| <br>A COMPANY OF THE SWATCH GROUP | <b>Product Change Notification PCN</b> | <b>Nr. 180312-12</b><br>Publishing Date: March 21 <sup>st</sup> , 2018 |

| Product information         |                                                            |                                                                                                                                                                                                                                                                                                                  |     |
|-----------------------------|------------------------------------------------------------|------------------------------------------------------------------------------------------------------------------------------------------------------------------------------------------------------------------------------------------------------------------------------------------------------------------|-----|
| Item affected / Type        | Tray for Holder HU2430-LF                                  |

## Foam tray change to PS tray SMTU/HU holder series

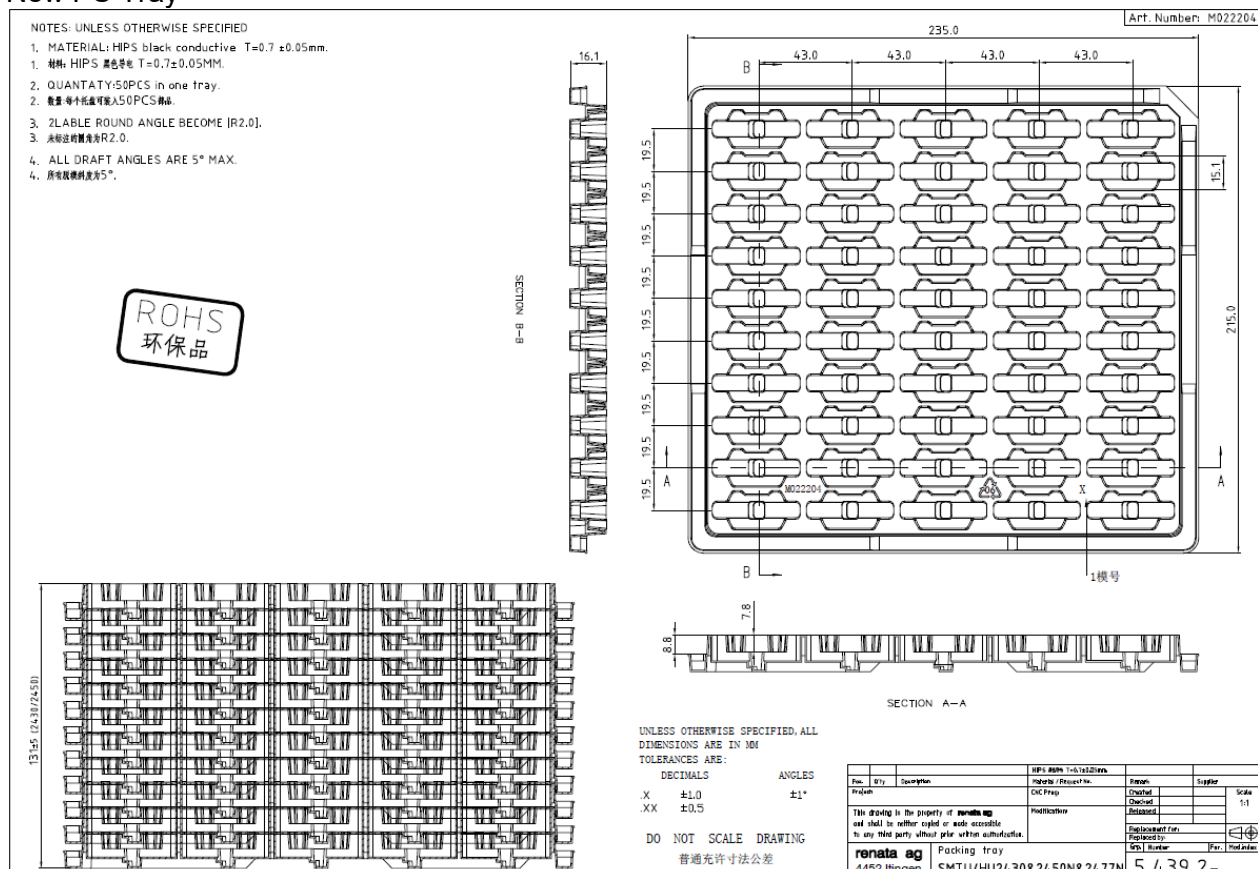
|                             | <p>Replacement of existing foam trays with PS (Polystyrene) material trays</p> <p>Drawing no. of Foam tray 5.270.1-<br/> Drawing no. of PS tray 5.439.2-<br/> Both drawing in attachment to compare.</p> <p>Same functions as PS tray<br/> Antistatic value: <math>10^3 \sim 10^6</math><br/> Quantities per Tray and also per shrunk pack will be kept unchanged.<br/> Placing of holders within in tray will remain unchanged</p> <p>Height of unit packing will be different.<br/> Current height for unit package foam tray: 109.0mm<br/> Estimate height for unit package PS trays 131.0mm</p> <p>Manufacturer part number will remain unchanged Change will be controlled by Lot number.<br/> Rolling change expected. Rollout of old tray expected to start in July 2019</p> |
